Rolling Knolls Landfill Superfund SITE

FIELD CHANGE REQUEST (FCR) FORM

REQUEST NO: 08 DATE: 06/~~09~~25/2015 ~~(revised 06/18/2015)~~

FCR TITLE: Replacement of MW-13 with Pore-water Samplers

FIGURE
1

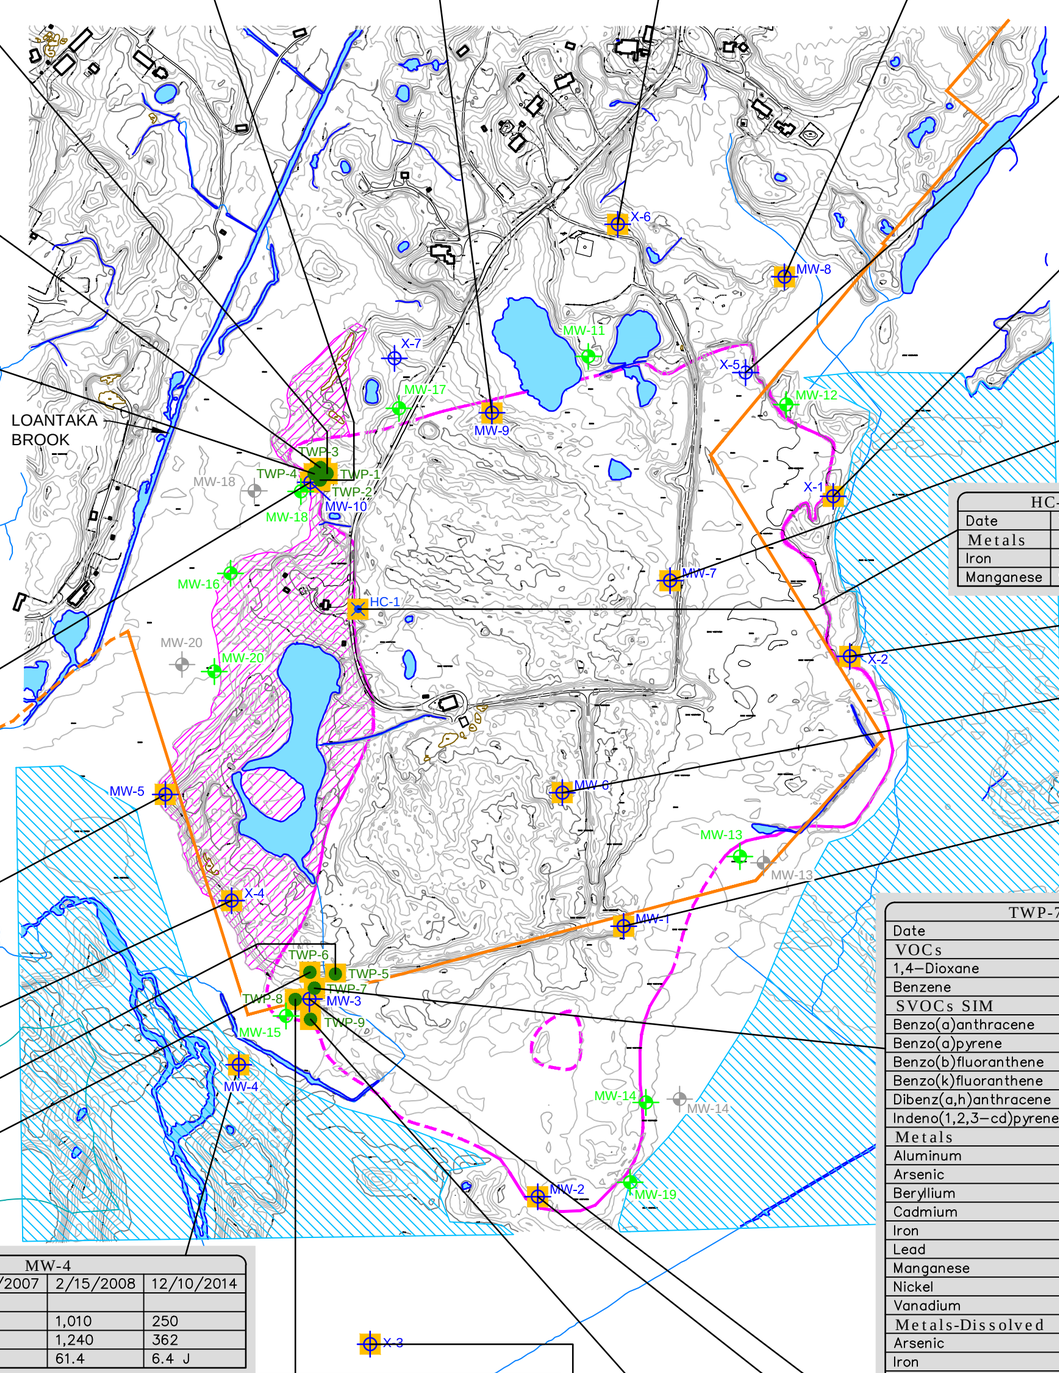
The Data Gaps Sampling and Analysis Plan (Data Gaps SAP) proposed installing seven permanent monitoring wells (MW-11 through MW-17). The Data Gaps SAP indicated the final locations of the permanent monitoring wells will be determined based on the results of the soil sampling and the temporary monitoring well samples collected as part of the data gap sampling. These data, and a proposal for the locations of the permanent monitoring wells, were transmitted to USEPA for review and approval on February 17, 2015. Additional supporting information was transmitted to USEPA on February 27, 2015. The USEPA responded on March 5, 2015 and requested adjustments to the locations of MW-12 and MW-15. The USEPA also requested the installation of three additional monitoring wells (MW-18 through MW-20). One of the proposed monitoring wells (MW-13) was to be located in an area later found to be inundated with water and is not a suitable location for a permanent monitoring well. Additional locations have been investigated; however, no appropriate relocation for this well has been identified. Consequently, the USEPA requested that pore-water samples be collected in place of this monitoring well.

Prior to installing the monitoring wells, ARCADIS personnel and a USEPA representative inspected each proposed monitoring well location. The proposed location for MW-13 was in approximately 6 to 24 inches of standing water. The location could not be moved to an area with no standing water, while still meeting the objective of delineating soil sample results from SS-157 and SS-158. USEPA was informed of these field conditions on May 28, 2015. As a result, on June 4, 2015, the USEPA requested pore-water samplers be placed at the MW-13 location, shown in green on Figure 1.

Monitoring well MW-13 will be replaced with porewater samplers. Regenerated cellulose membrane samplers will be used to collect volatile organic compounds (VOCs), metals (unfiltered only) and cyanide. Additional pore-water will be collected using PushPoint techniques and analyzed for semi-volatile organic compounds (SVOCs), pesticides, and polychlorinated biphenyls (PCBs) (as Aroclors). Certain SVOCs will be analyzed by SIM to obtain a lower detection limit. Sampling procedures will follow those approved in the Quality Assurance Project Plan (approved by USEPA on December 18, 2014) using standard operating procedures (SOPs) 20 and 21. If the pumping rate in the PushPoint samplers is low, it may be difficult to retrieve all the required volume for sample analysis within a sampling period of one 12-hour field day. In that case, the following order of priority for analyses will be used, as listed in Table 1 of the Data Gaps SAP for previously proposed pore-water samples (approved by USEPA on November 18, 2014) unless otherwise noted:
